Application Name: Graythwaite Concept Plan
Application No.: Concept Plan (MP10_1049)
Stage 1 Application (MP10_0150)

Submission – OBJECTION TO REVISED EA APPLICATION

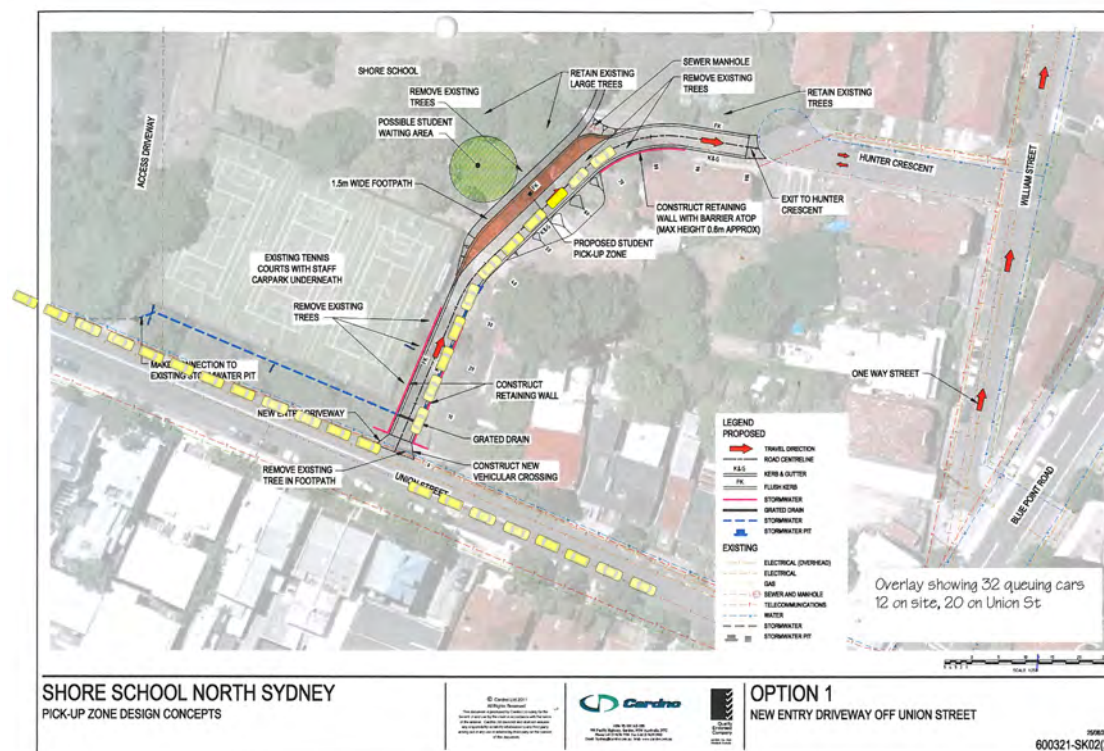
The application proposes options for a new student drop off with entry from Union St, or reverse direction alternates with entry from William St / Hunter Cres. Nowhere in any of the reports or the optional studies has there been any attempt to analyse or disclose the queuing demand nor capacity of any of these options.

The proper professional approach is to analyse and quantify the potential demand for queuing spaces, and then analyse the actual queuing capacity of the options presented. We can only assume that this vital missing information has been withheld. It demonstrates the complete failure of the total approach to traffic planning for this application, which result in external community impacts that would be clearly unsustainable and unacceptable had they been properly revealed. The diagram below (by the resident group) is typical of the information that should have been provided but has been withheld.

As mentioned in our analysis later, the applicants figures result in an afternoon queuing demand of 32 spaces for the 15 min. period leading up to pick up time. But the basic option for the pickup design, Option 1, has onsite capacity for only 12 cars.!

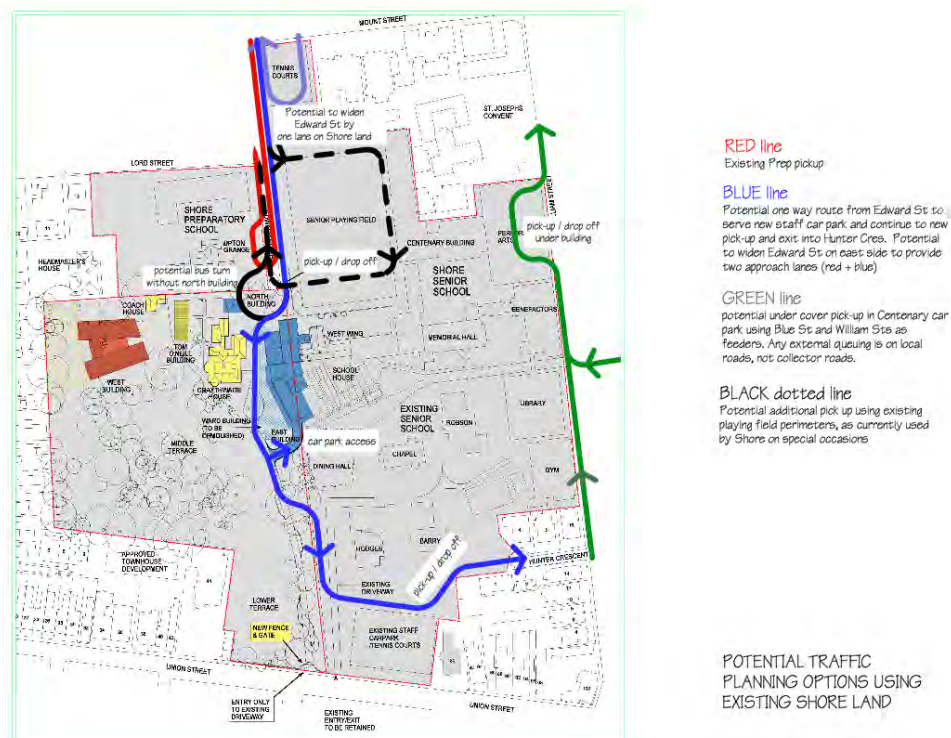
Below is a resident diagram that shows some alternate traffic routes that clearly would assist in minimising the external impact, and we strongly believe the applicant must go this process and reach an acceptable balance between managing traffic on its own land and minimising the use of public roads for their personal use at the expense of the community.
